CORRECTIONS (Feb 2006):

SCHEMATIC OF THE HEATHKIT®
DIGITAL WIND SPEED/DIRECTION INDICATOR
MODEL ID-1590/ID-1590E

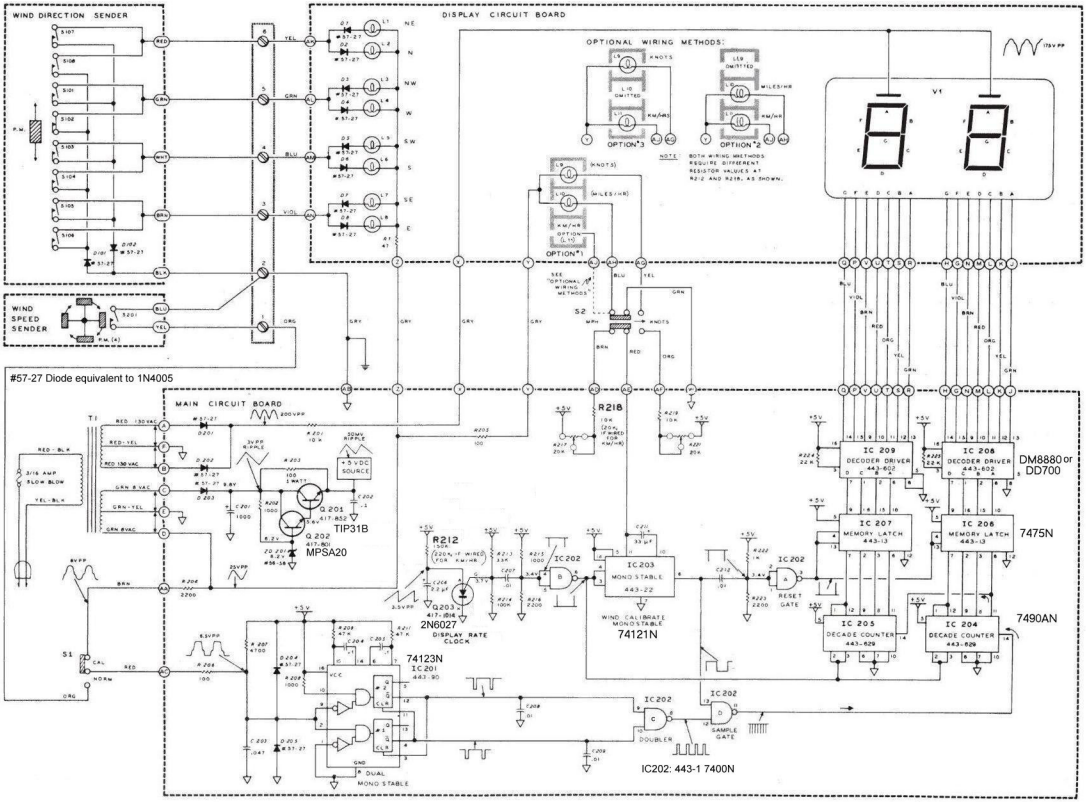
1. Q203 was drawn as a SCR, and not as a PUT.
2. Optional Wiring Note (bellow Option #2) mistakenly refers to "R212 and R2118".It should read "R212 and R218".
3. Pin of IC201 that goes to R209/C204 is marked as 13. It should be marked as pin 15.
4. Generic Part Number added for IC's and TR's.
5. IC202 gate denomination "D" changed to "C".
6. IC202 gate denomination "E" changed to "D".
7. Component ID's not used: R210, R211, C210.
8. IC207 pin labeled as "1" should be labeled as "7" (IC206 is correct).
